AGENDA
PLANNING COMMISSION PUBLIC HEARING/REGULAR MEETING
CITY OF FARMINGTON HILLS
JULY 16, 2026 at 7:30 P.M.
FARMINGTON HILLS CITY HALL – CITY COUNCIL CHAMBER
31555 W. ELEVEN MILE ROAD, FARMINGTON HILLS, MICHIGAN 48336
Cable TV: Spectrum – Channel 203; AT&T – Channel 99
YouTube Channel: <https://www.youtube.com/user/FHChannel8>
www.fhgov.com (248) 871-2540

A. SITE PLAN 55-6-2026

LOCATION:	24435 Halsted Road
PARCEL I.D.:	22-23-19-426-013
PROPOSAL:	Outdoor used motor vehicle sales, reconditioning and service in LI-1, Light Industrial District.
ACTION REQUESTED:	Site Plan Approval
APPLICANT:	Hayder Alkhafaji
OWNER:	HFR Capital, LLC

Site Plan Review for The City of Farmington Hills

SHEET #
SP.101

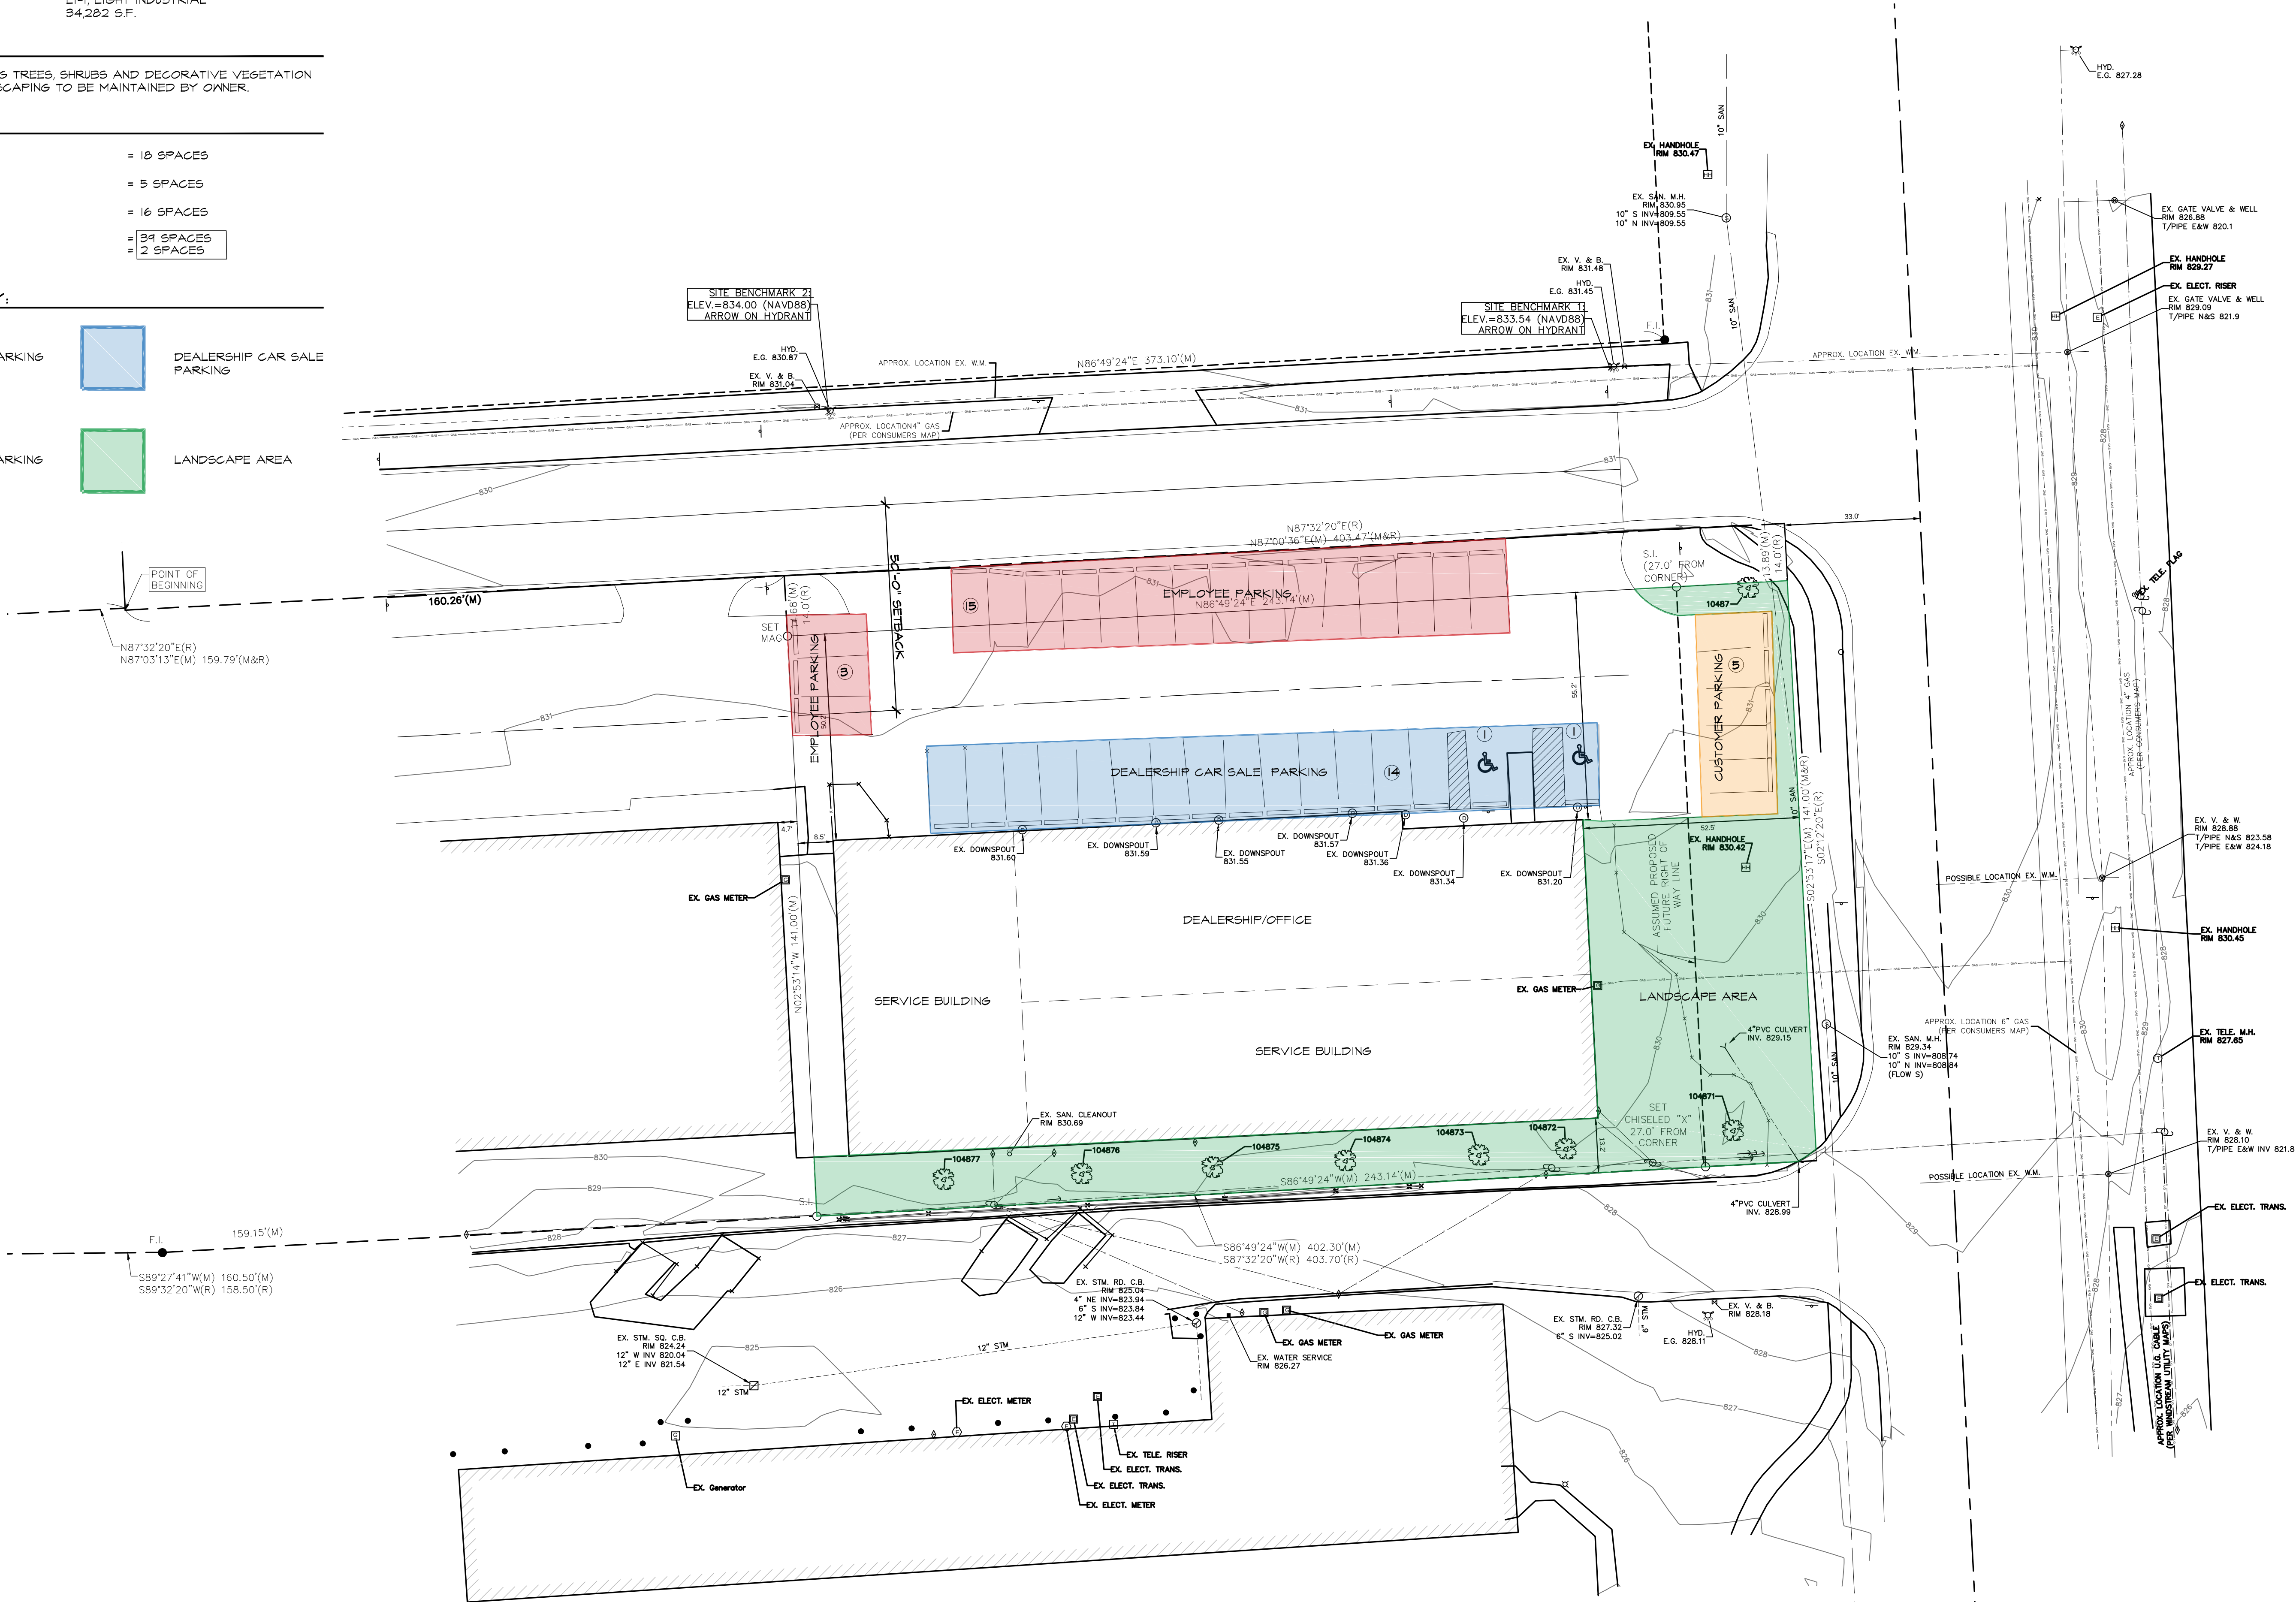
Barrier-free parking spaces (34-5.3.3.E)	Lots with 26 to 50 spaces = Two (2) barrier free spaces.	Pending. Two (2) barrier free spaces are proposed. However, the site plan indicates they will be used to display vehicles for sale. This must be corrected.

- 1) *The site plan must be updated to indicate that the barrier free spaces will not be used for vehicle display.*
- 2) *The existing drive does not comply with the intersection offset requirement listed in 34-4.36.1.B. The applicants may request a variance from the Zoning Board of Appeals.*
- 3) *Dumpster enclosure details must be provided to demonstrate that the enclosure is in good condition and provides adequate screening.*
- 4) *A loading space is not designated on the plan. The applicant may request a variance from the Section 34-5.4.3.A loading space requirement.*
- 5) *The applicant may request a variance from the Section 34-5.4.3.D loading space setback requirement.*
- 6) *The hours of operation specified in Section 34-5.16.3.B.v must be noted on the site plan.*
- 7) *The applicant must confirm if any exterior building renovations are proposed.*

SHEET TITLE
DEMOLITION
PLANS

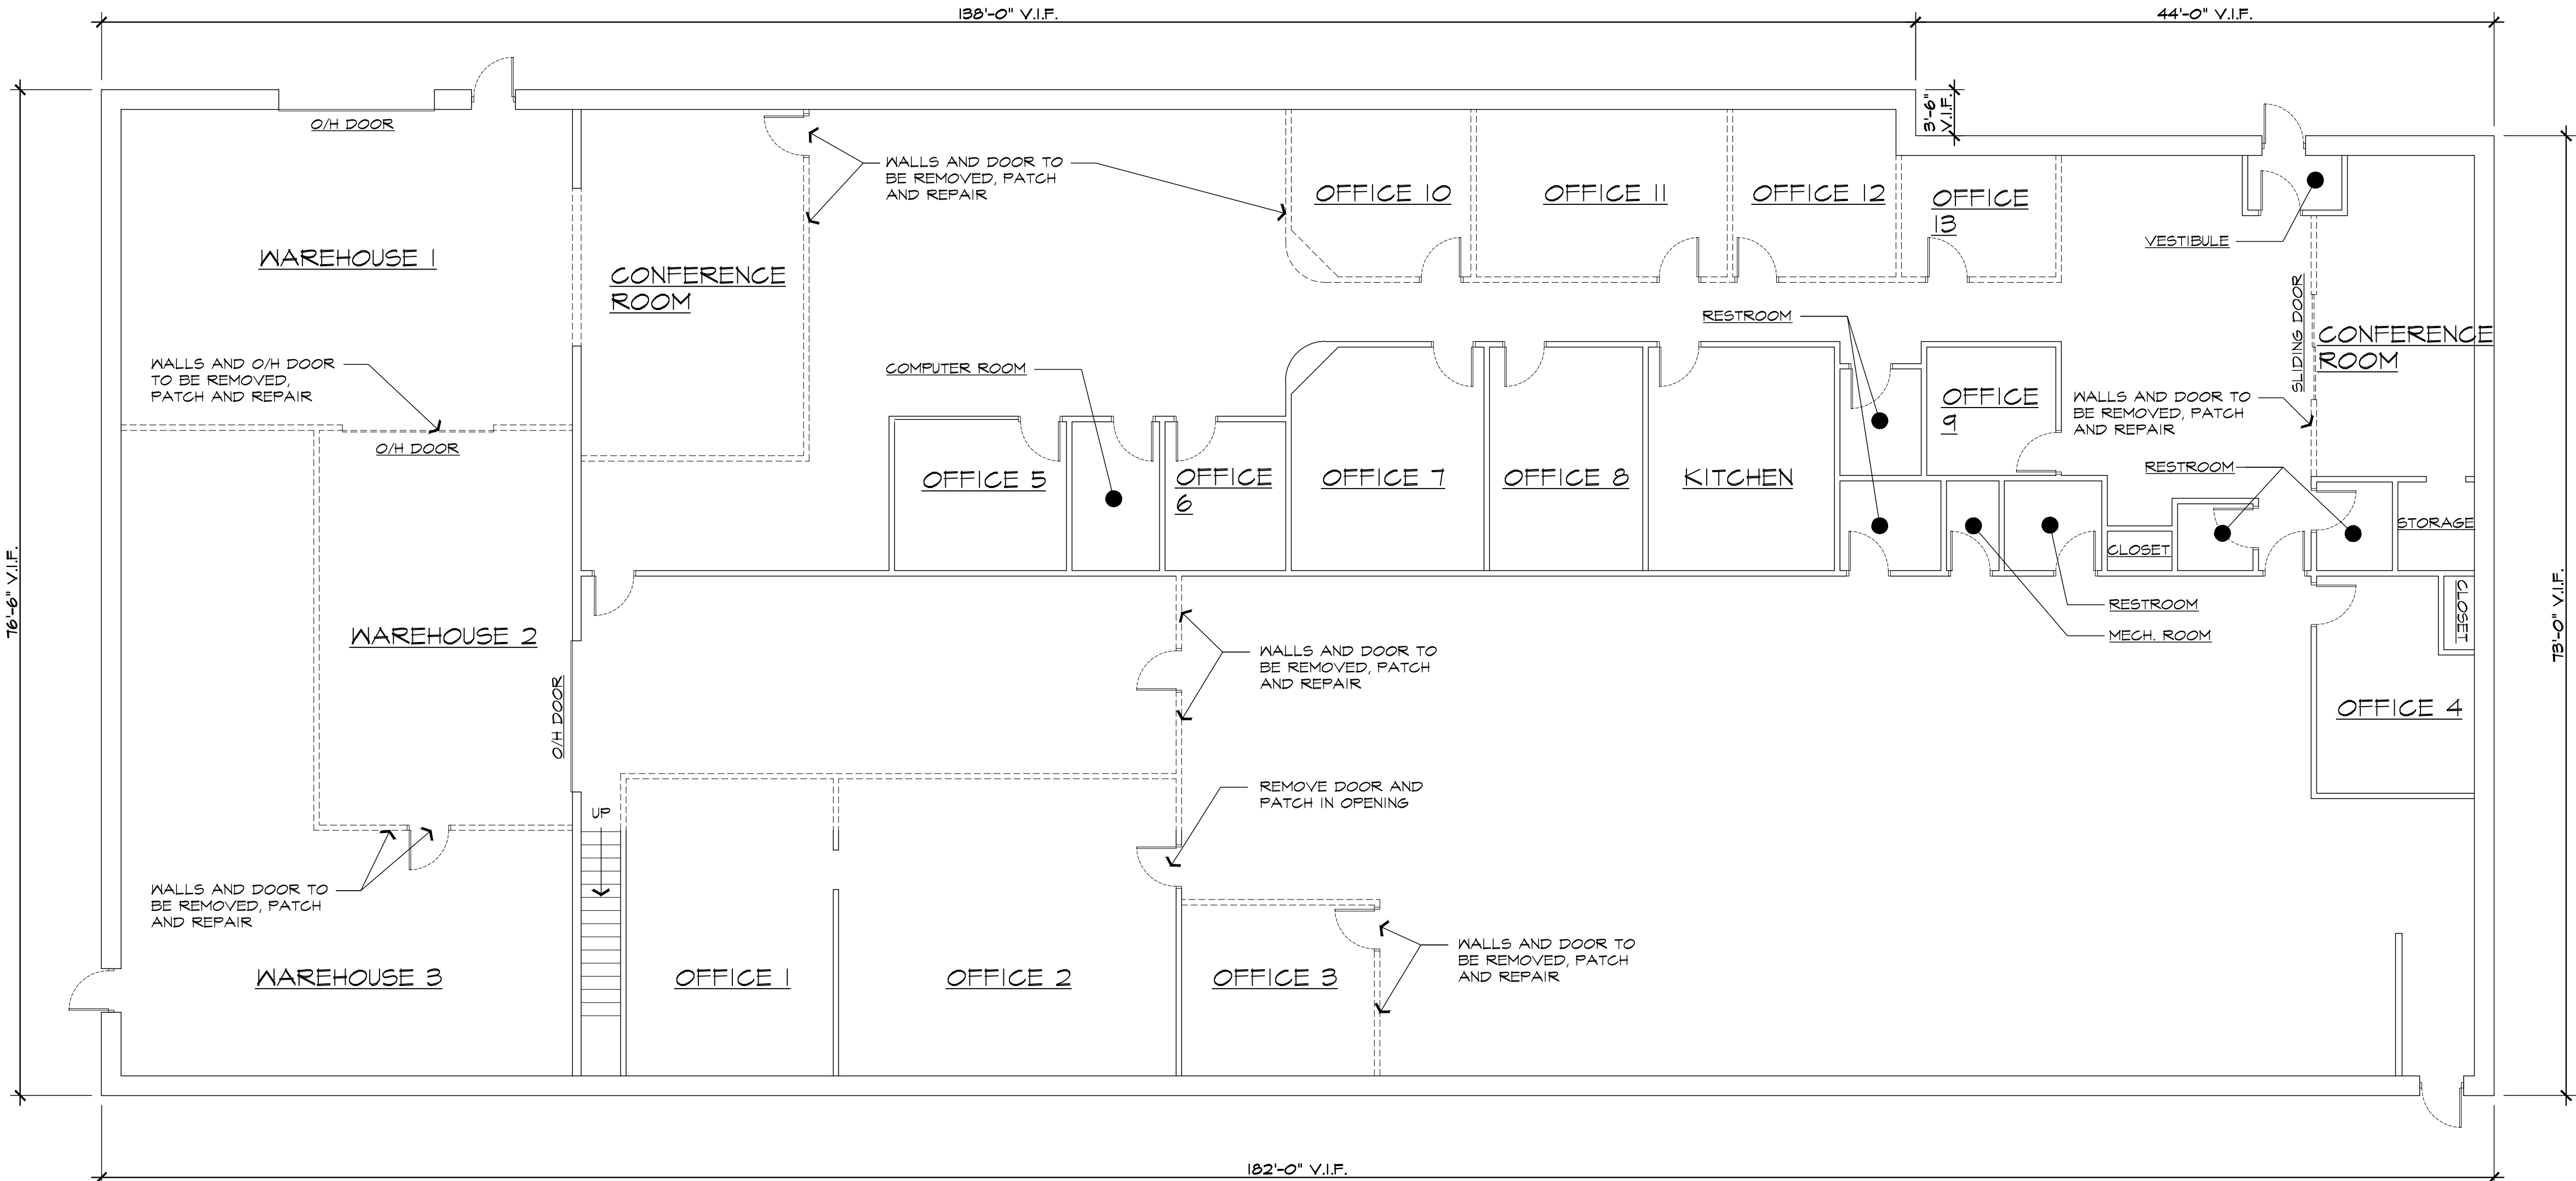
1. A Demolition Plan must be provided for any site alterations being performed.
2. The existing water service and sanitary lead to the building must be shown on the plan. If the existing sanitary sewer lead will be reused, it must be televised and the video must be provided to the city for review/assessment prior to the final engineering review.
